SERVICE DIRECTIVE BULLETIN NO. 0109

1. SUBJECT: Idler Yoke Inspection, P/N 28-13299-1
2. MODEL: F-28A, 280, F-28C, 280C, F-28F, 280F, and 280FX
3. EFFECTIVITY: Aircraft built after May 2006.
Aircraft that had a P/N 28-13299-1 Idler Yoke installed after May 2006.
Any P/N 28-13299-1 Idler Yoke in stock.

Figure 1 – Idler Yoke, P/N 28-13299-1

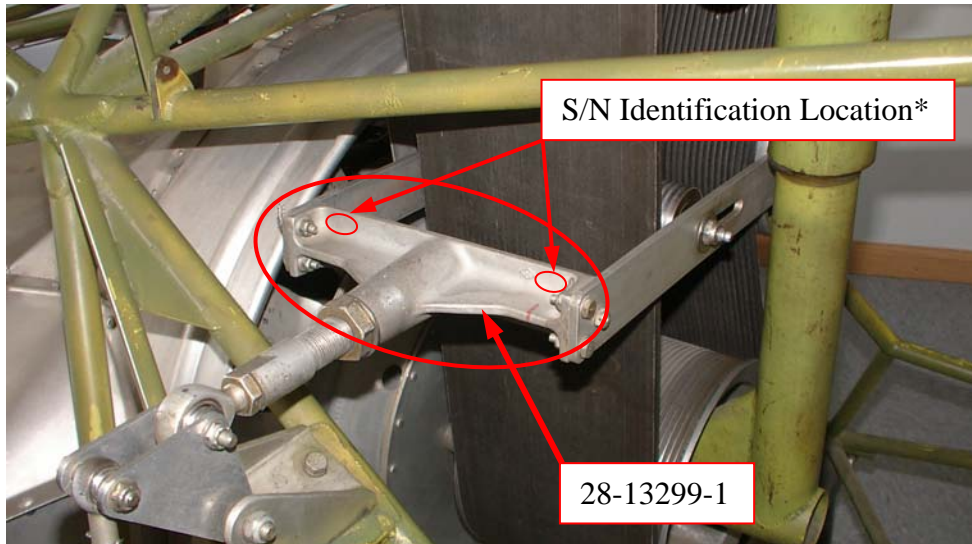
- A. Within five hours, locate the idler yoke serial number (S/N) engraved on the casting. Refer to Figure 1 for locating the serial number.

* S/N identification will be located in one of the four corners.

- B. If the S/N is within the range 14-001-06 to 14-077-06, the idler yoke must be inspected. Proceed to step 5.2.

- C. If the S/N is not in this range, no inspection is required. Note that the serial number format has changed over the years and older serial numbers may not be in the ##-###-## format (these are not affected).

Figure 2 – Idler Yoke Dye Penetrant Inspection Areas

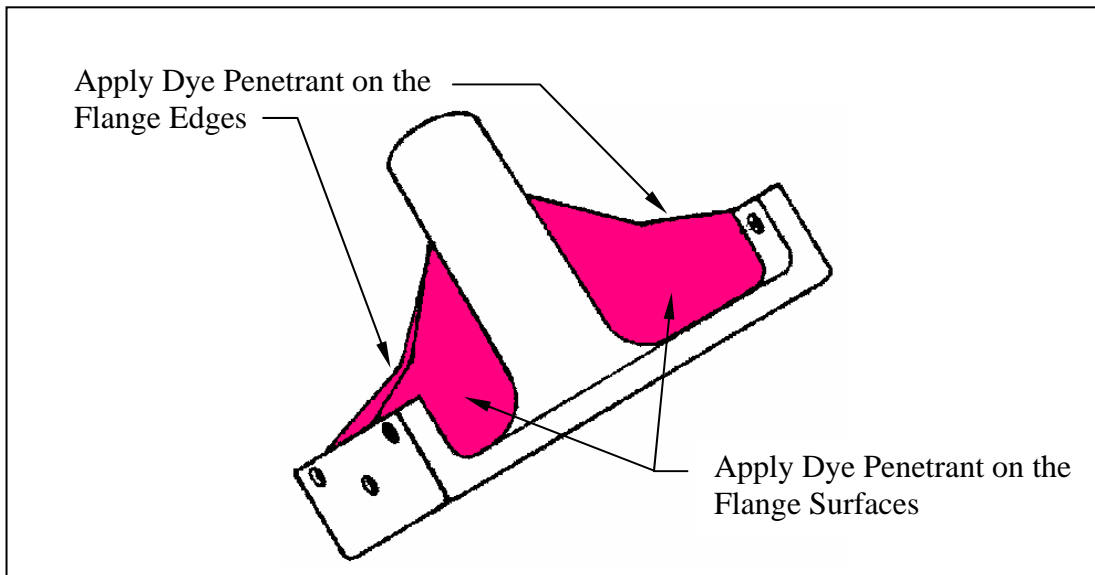
- A. Within the next 5 hours time in service, inspect the idler yoke for cracks (reference Figure 1 and Figure 2) using dye penetrant method. Follow the dye penetrant manufacturer's instructions.

1. A heavy, solid line bleed-back indicates a crack. Reject the idler yoke and replace with an airworthy idler yoke, P/N 28-13299-3.

2. Some porosity is normal for this casting. For any bleed-back indications greater than 2% of the treated area, contact Enstrom Customer Service.

3. If no bleed-back indications are present, the inspection is satisfactory. Thoroughly clean the idler yoke per the penetrant kit instructions.
